Your Ref: 63 and 83 Church Street
Our Ref: LTR003-02-23-1102 - 63 & 83 Church Street Flood
Assessment Report Site 1 & 2

RE: 83 Church Street (Site 1) and 63 Church Street (Site 2), Parramatta
Flood Planning Statement for Planning Proposal

Table 2: Response to advice received from Council

below (refer to markup of the figure provided by Council for location references):

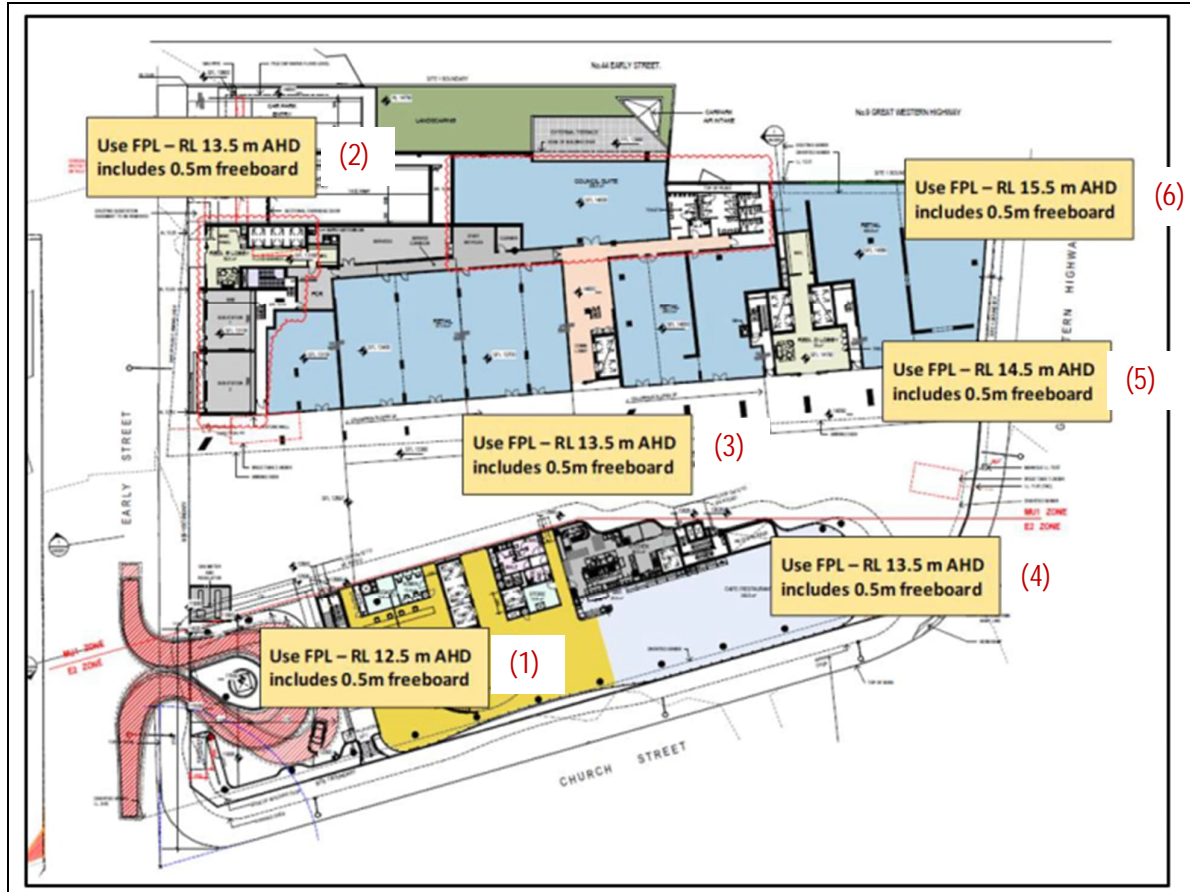
Council Advice	AT&L response
<i>It is noted that there are proposed changes to a number of the levels within the site (including the central plaza and the driveway).</i>	Council's advice in the Record of Pre-lodgement Application Meeting indicates varying FPLs across the proposed development. Comment regarding the adopted FFLs at each of these locations is outlined

You are advised that Council has new flooding information available which will need to be closely considered in your modification application.

There are indications that some parts of the site would not now comply with acceptable flood levels generated by overland flow and would be required to be raised. Other parts may be satisfactory.

However as no overland flow study has been carried out by the applicant this cannot be confirmed.

Offices and storage of valuable items including retail storage are unlikely to be acceptable below ground and below the FPL. Other proposed 'non-habitable' uses will be assessed on merit.

All habitable floors must be at or above the flood planning level which is the 1% AEP flood level plus 500mm freeboard.

Pending adoption of Council's Flood Study, the following levels identified as Flood Planning Levels (FPL) may be used for this purposes of this application. Minimum finished floor levels of habitable rooms should be considered in the design.

(1) Hotel Lobby

The adopted hotel lobby FFL is 12.90 mAHD (400mm above the FPL as per Council's recent advice).

(2) Residential Lobby

The adopted FFL of the residential lobby is 14.00 mAHD (500mm above the FPL as per Council's recent advice).

(3) Retail fronting Colonnade

The FFL of the retail spaces fronting the colonnade are proposed to vary between 13.40 mAHD and 14.00 mAHD (compared to a FPL as per Council's recent advice of 13.50 mAHD). The FFL of the two western-most retail spaces would be nominally 100mm below the FPL. As this part of the development is non-habitable the DCP requirements relating to floor level are not applicable.

(4) Café / Restaurant

The adopted FFL of the Café / Restaurant is 12.90 mAHD, which is 600mm below the FPL as per Council's recent advice. As this part of the development is non-habitable the DCP requirements relating to floor level are not applicable.

(5) Retail fronting Colonnade near Great Western Highway

The FFL of the retail space fronting the colonnade near GWH is 14.35 mAHD (compared to a FPL as per Council's recent advice of 14.50 mAHD). As this part of the development is non-habitable the DCP requirements relating to floor level are not applicable.

A detailed assessment will be undertaken to confirm the need or otherwise for flood barriers at the Residential E Lobby to address the risk of flood flows into the basement via the four residential lifts.

(6) Retail fronting Great Western Highway

The FFL of the retail spaces fronting the colonnade near GWH are 14.82 mAHD and 15.25 mAHD (compared to a FPL as per Council's recent advice of 15.50 mAHD). As this part of the development is non-habitable the DCP requirements relating to floor level are not applicable.
